Addendum #2

To: Bidders
From: Jennifer Wilson
CC: Kilina Goldenberg, Greene County
Rob Rigdon, Greene County
File
Date: December 9, 2025
Project: Greene County Historic Courthouse – Recorder's Office, RFB#25-11117

To: Jennifer Wilson
From: Brad Palmer
Date: 12.9.2025
Project Title: Greene County Recorder's Office - Springfield, MO

2 FIRST FLOOR MEP DEMO PLAN

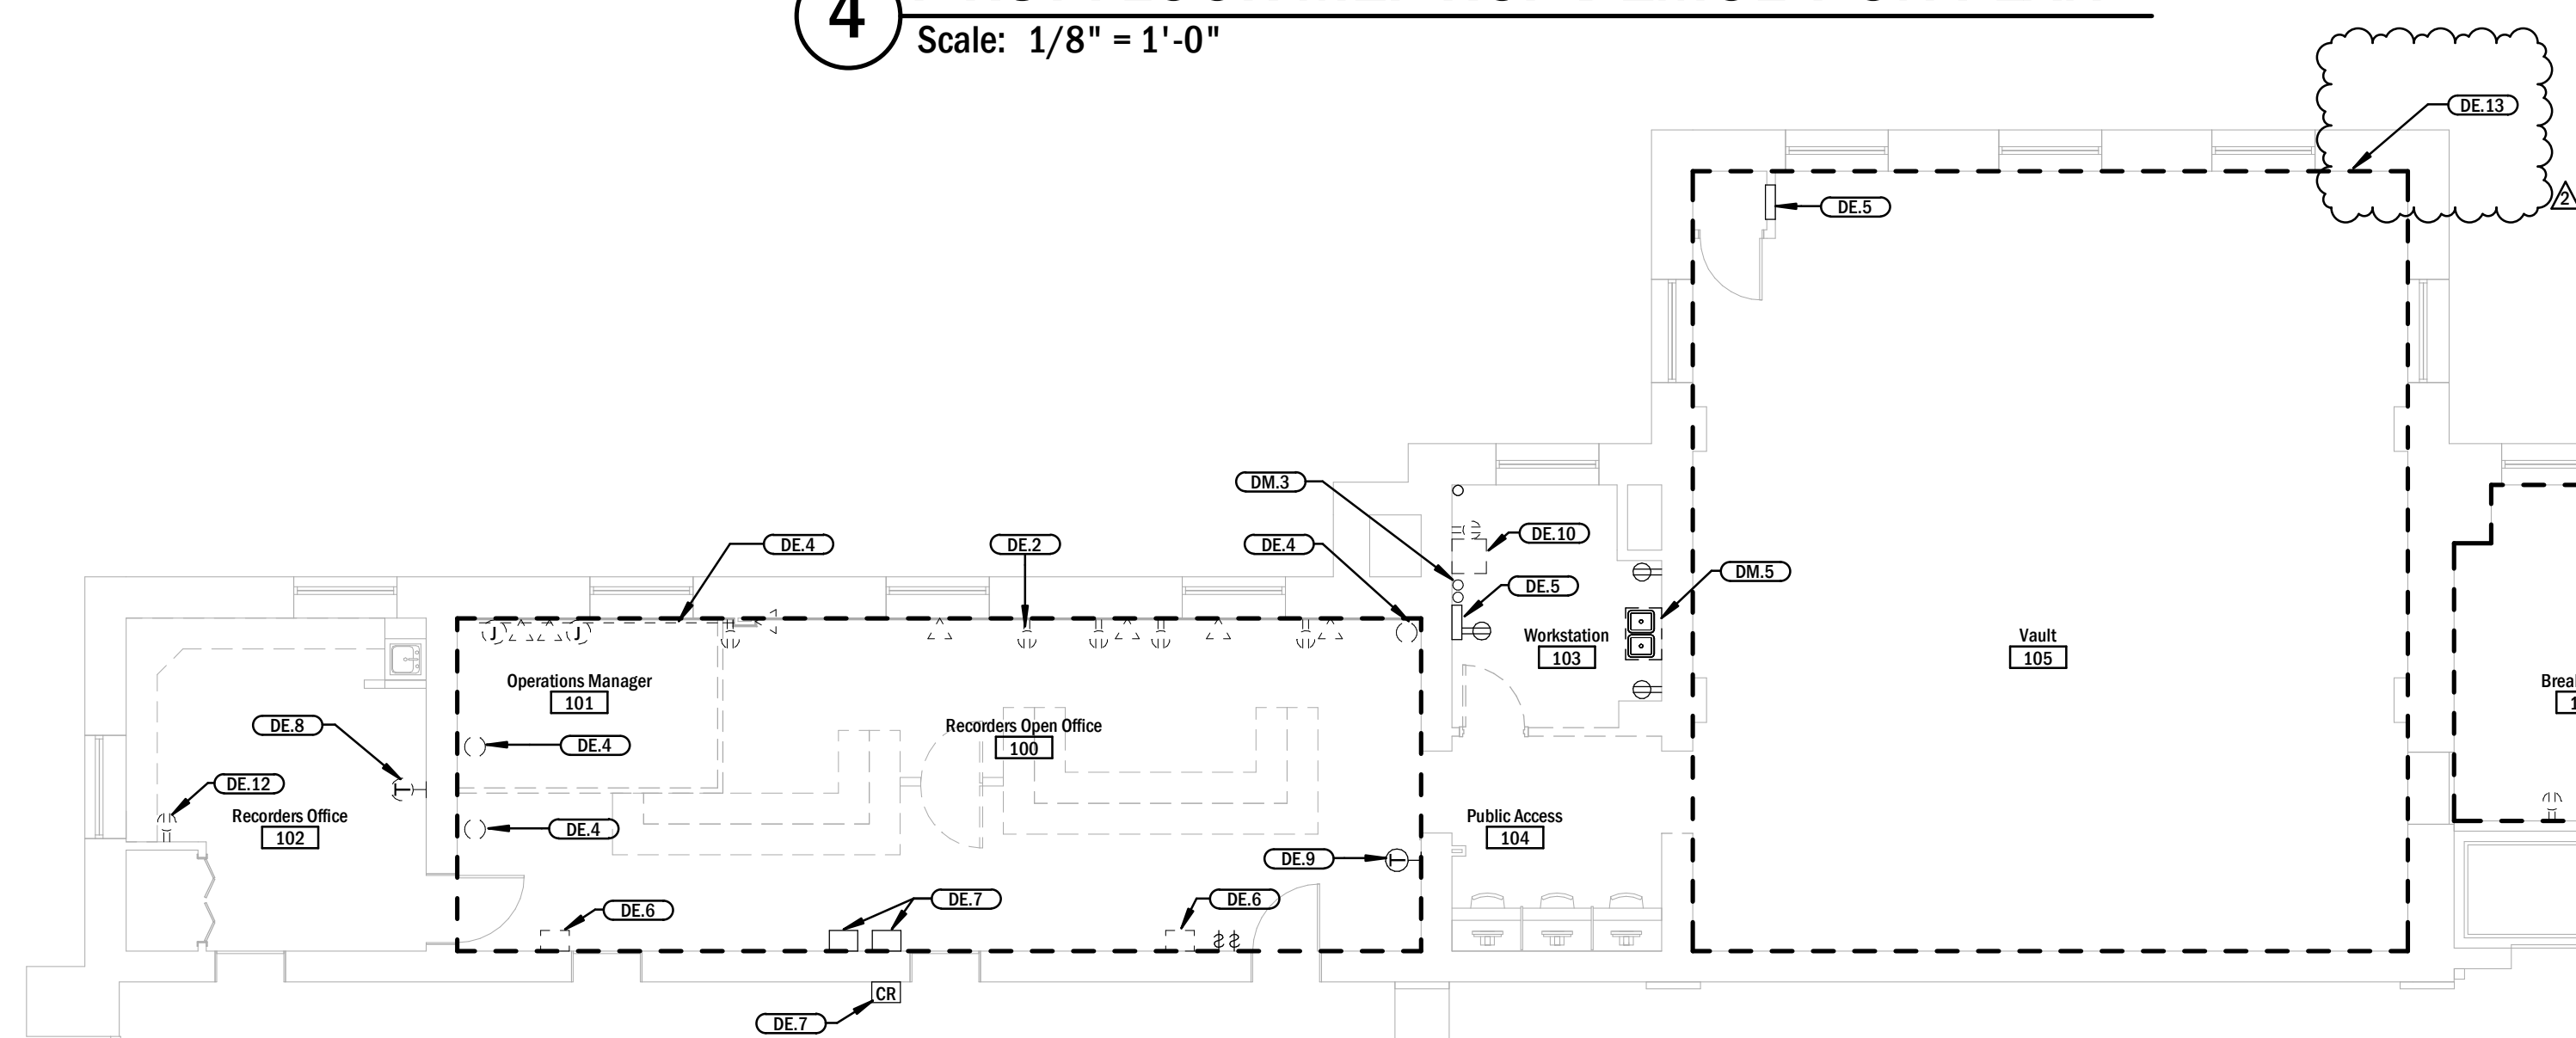
- a. ME101 – Requirements of electrical demolition work in vault 105 clarified a shown on attached revised sheet ME101. (Plan 2, Keynotes)
5. REVISION – Revised Data wiring requirements.

1 SECOND FLOOR MEP DEMOLITION PLAN

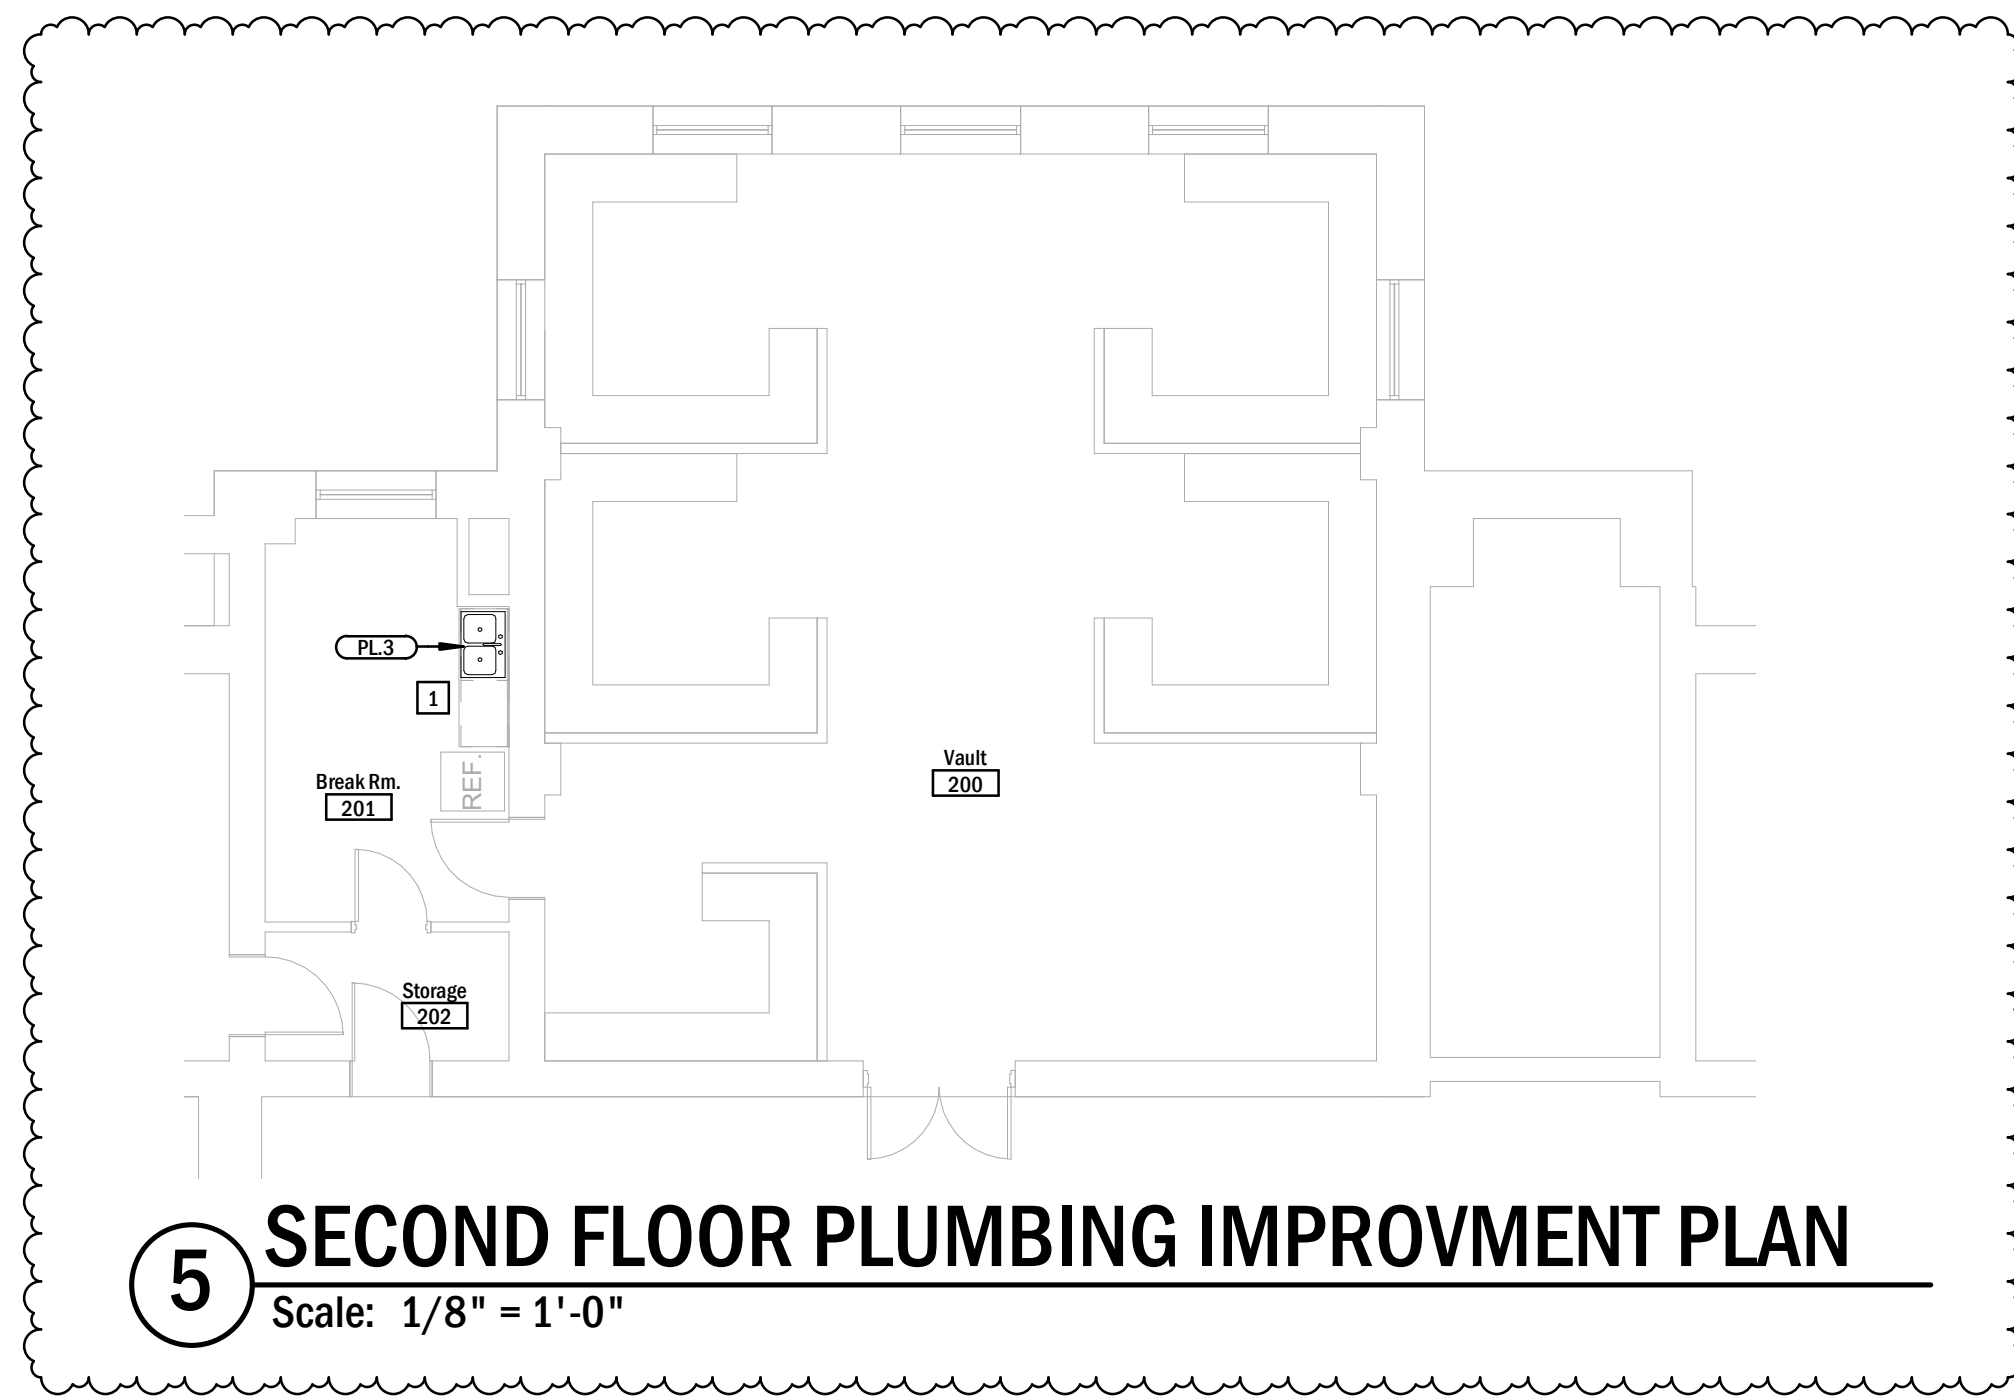
- a. ME101 – Second Floor Break Room demolition requirements updated as shown on attached revised sheet ME101. (Plan 1, keynotes)
 - b. P101 – Second Floor Plumbing Improvement plan added as shown on attached revised sheet P101. (Plan 5, Keynotes)

3 SECOND FLOOR POWER IMPROVEMENT PLAN
Scale: 1/8" = 1'-0"

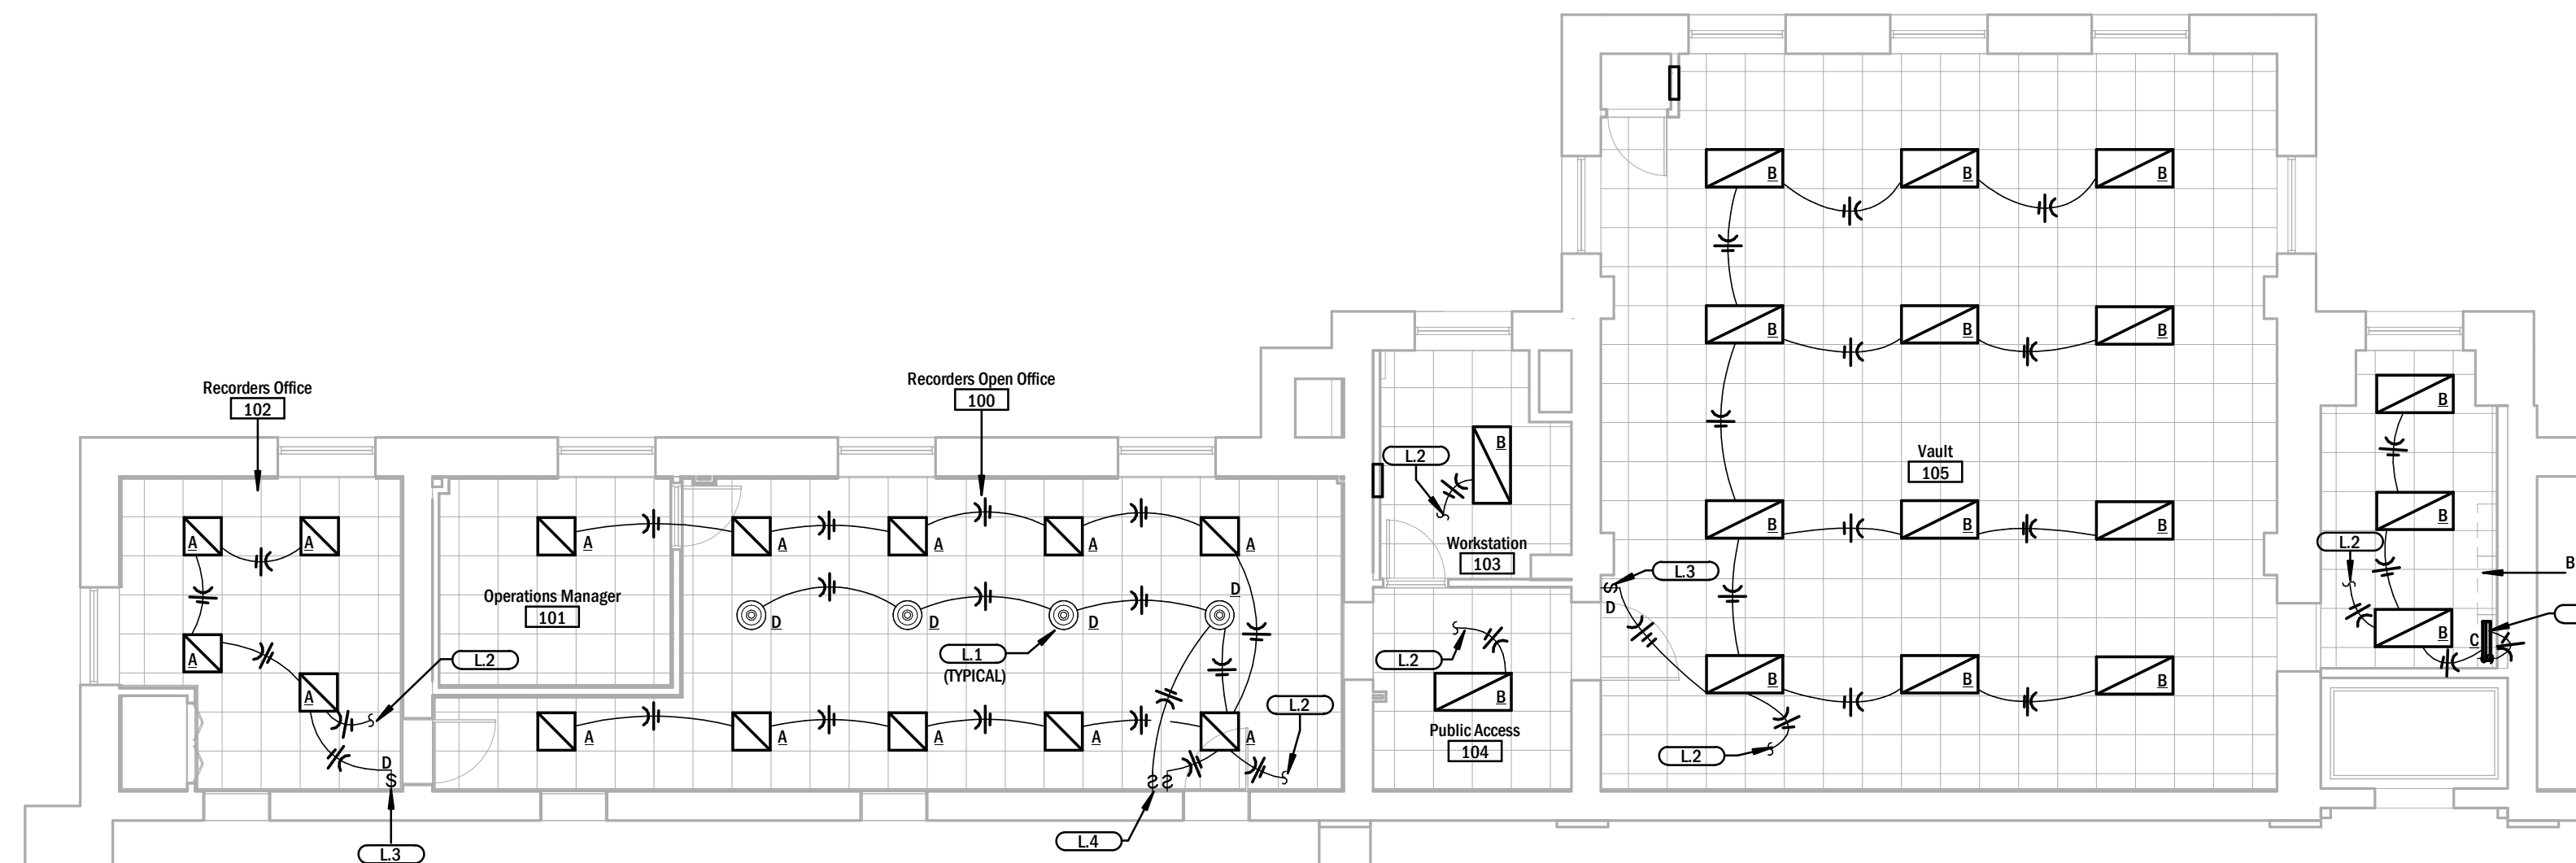
- c. E101 – Second Floor electrical improvements updated as shown on attached revised sheet E101. (Plan 3, Keynotes)
4. CLARIFICATION – Requirements of demolition work in Vault 105 clarified.

6 DATA ROUGH IN DETAIL

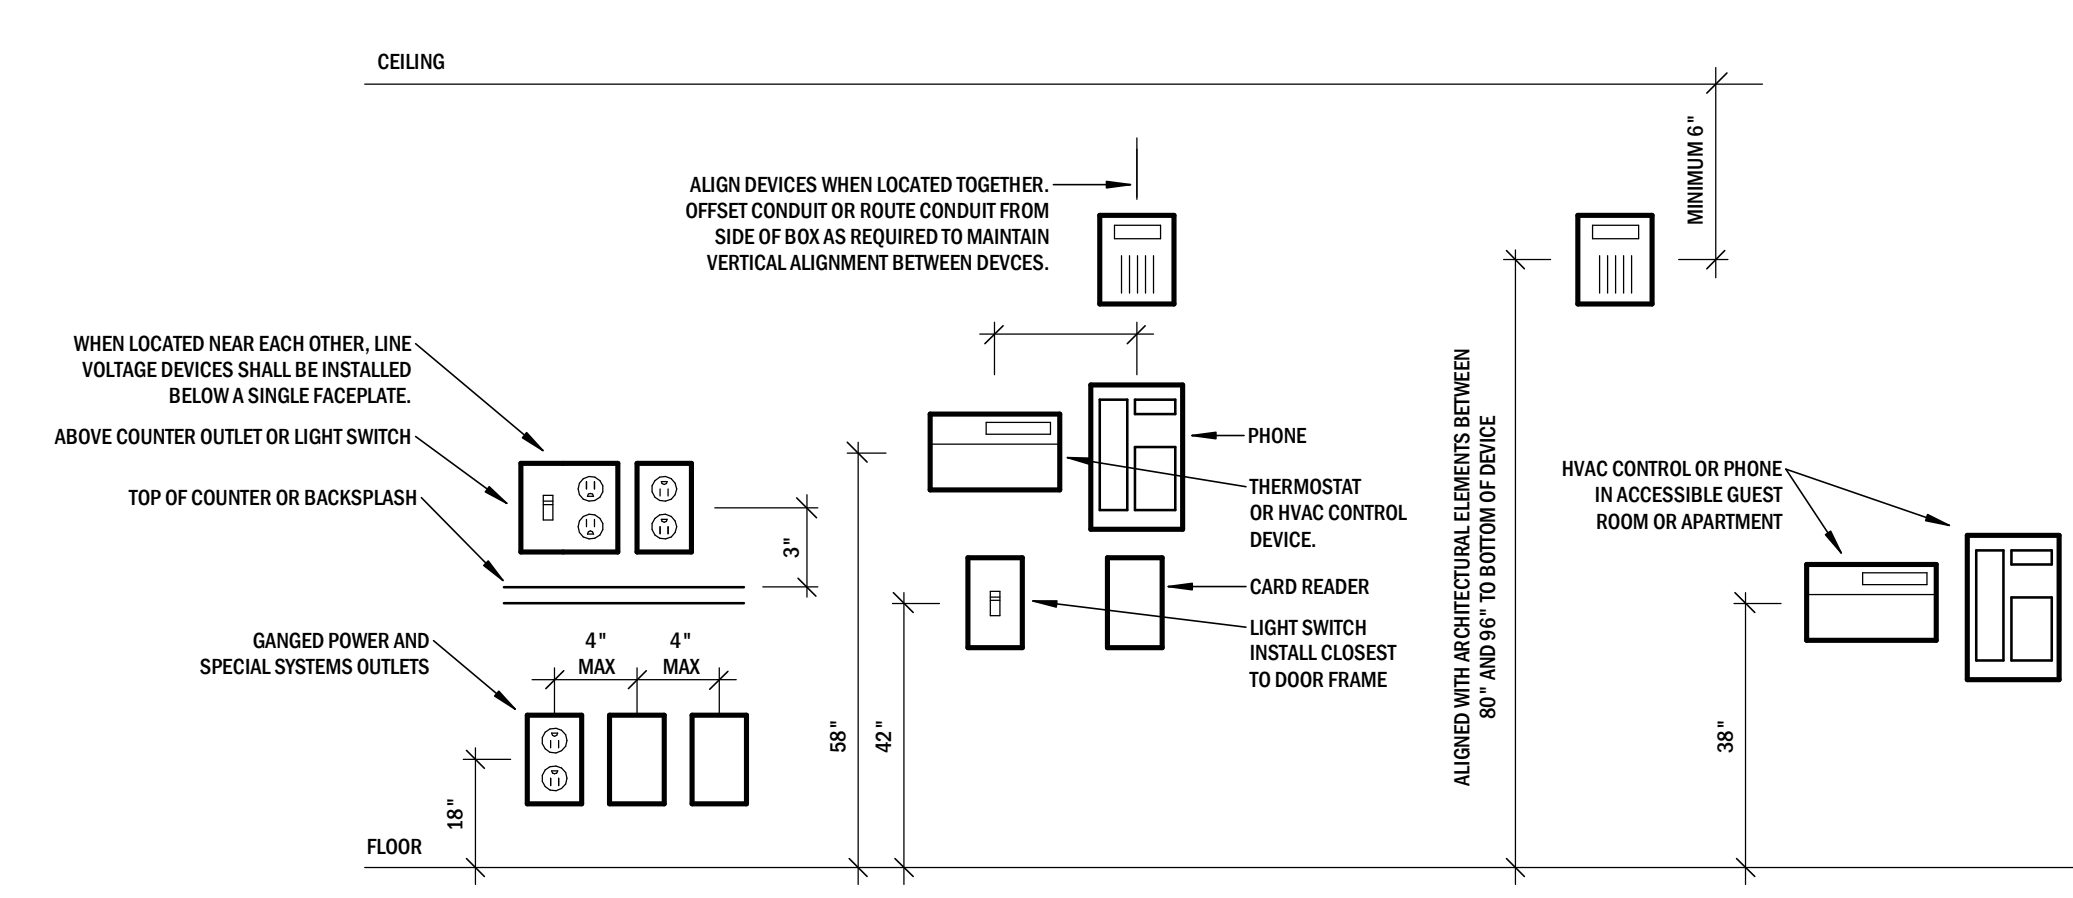
- a. E201 – Revise Data and conduit wiring requirements as shown on attached revised sheet E201. (Detail 1, Detail 4, Detail 6)
